Listuguj Mi'gmaq Government

ADDENDUM No. 2

Construction of a Triplex

May 15, 2026

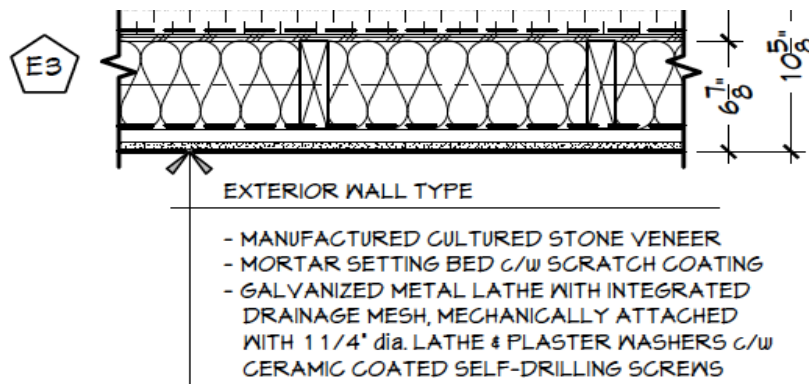
1. In regard to the electrical grid for the site location, currently there is no electrical grid therefore there is no access for a temporary hookup. Do you have an approximate timeline when the new grid will be installed?
Everything is scheduled to be installed by July 1st.
2. For the subfloor is stable edge tongue and groove 3/4" okay to use in lieu of what the plans say on F1 which calls for 3/4" plywood?

Yes, stabledge tongue and groove can be used in lieu of 3/4" plywood for the floor type material

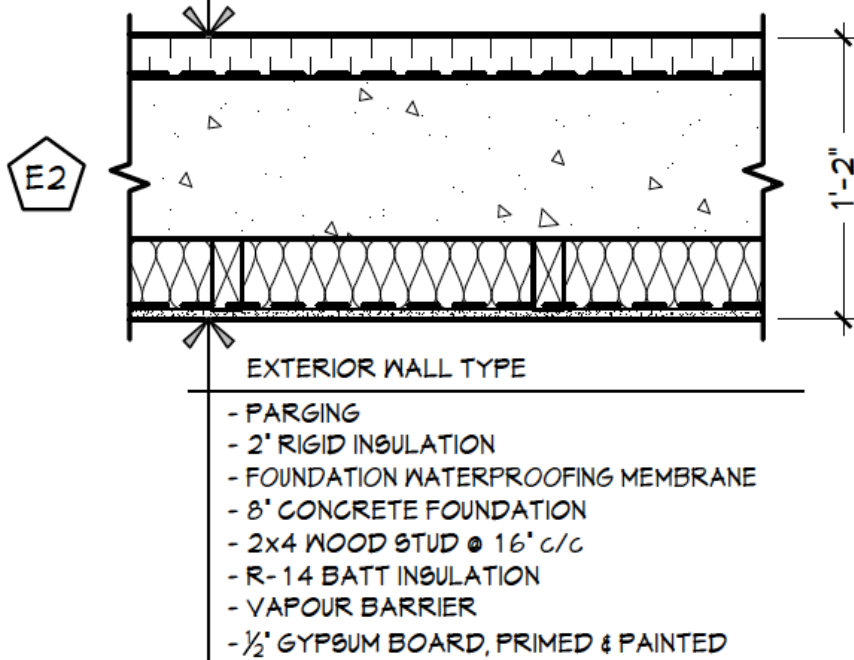
3. Are quality stone bricks which are screwed in without the need of mortar, mesh etc which are described in E3, acceptable?

All products should be similar to the product NOVIK 233 stone.
